Open Spectrum Submission

Proposal to remake apparatus
and broadcasting licence
condition determinations

Field strength condition is not fit-for-purpose

Figure 1—Area with line-of-sight (LOS) from a notional LPON transmitter at Yarralumla

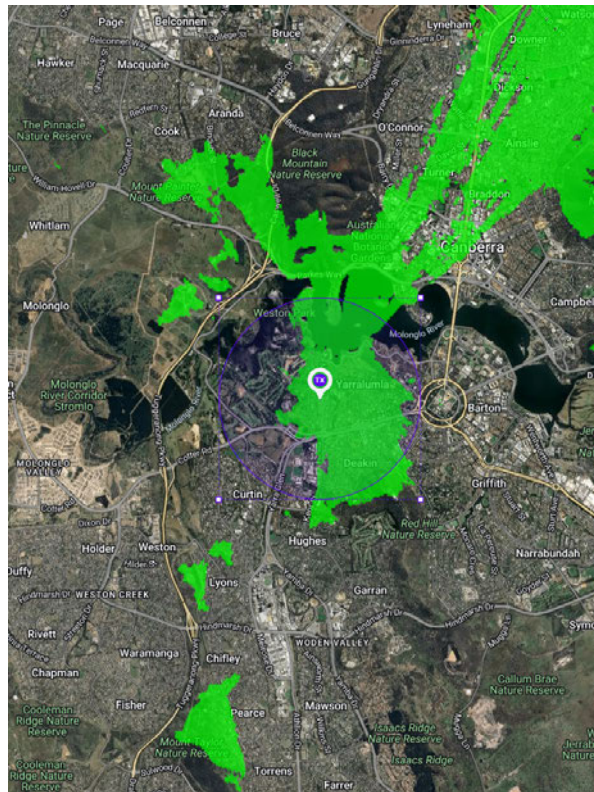
As can be seen in Figures 1 and 3, the assumption that there can be LOS, between two antennas at 10 metres above ground level, well beyond 2 km, is entirely reasonable. For Yarralumla, this is limited to a set of northerly and southerly azimuth ranges, however for Cobar, there is LOS at distances > 2 km for *most* azimuths/bearings.

Figure 2—Area for which 48 dBμV/m is exceeded from a notional LPON transmitter at Yarralumla using (a) Rec. ITU-R P.526 and (b) Rec. ITU-R P.1546.

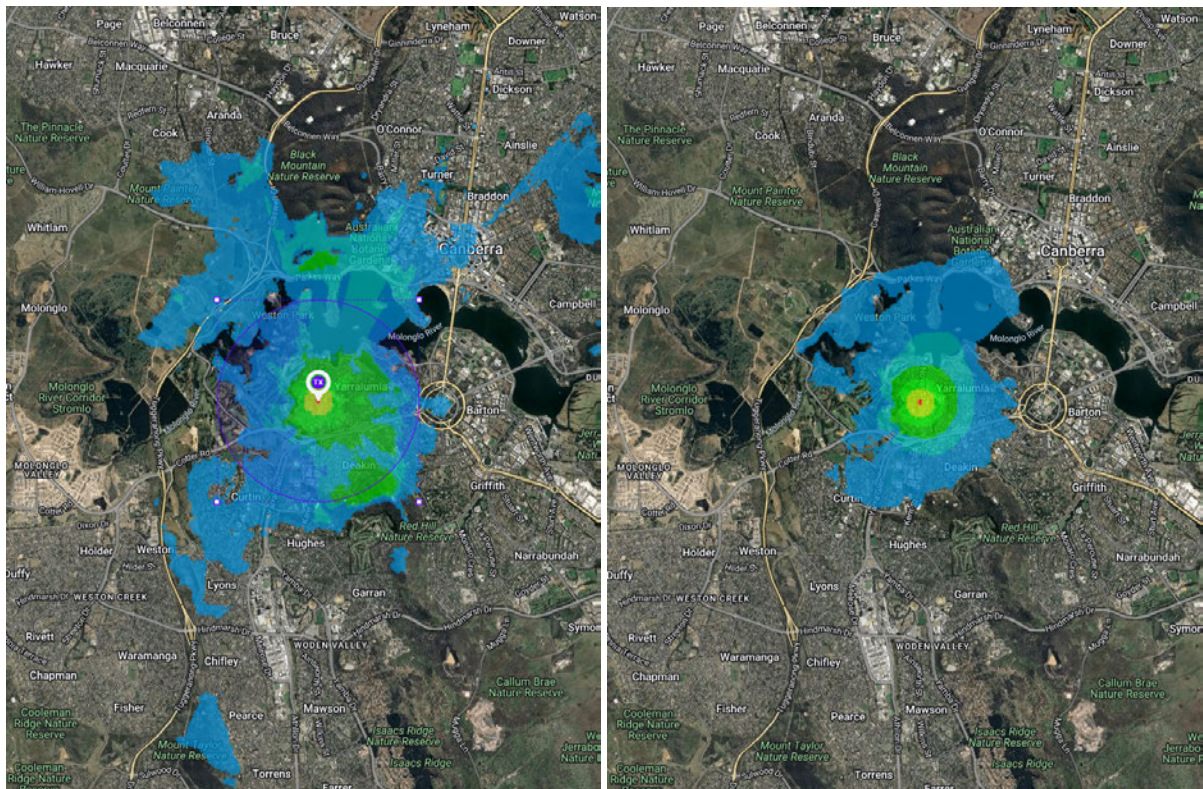
As can be seen in Figures 2(a) and 4(a), using Recommendation ITU-R P.526, the field strength can exceed 48 dB μ V/m even for NLOS paths well beyond 2 km, due to diffraction over terrain.

The only coverage plot for which containing the coverage to 2 km appears even close to being achieved, is when the propagation model used is Recommendation ITU-R P.1546—see Figures 2(b) and 4(b). However, P.1546 is an empirical model where path loss curves were generated from empirical data measured over a range of many propagation paths. It therefore makes assumptions about the path between the transmitter and receiver point which may not necessarily exist, although that “on average” may be expected to give a reasonable answer.
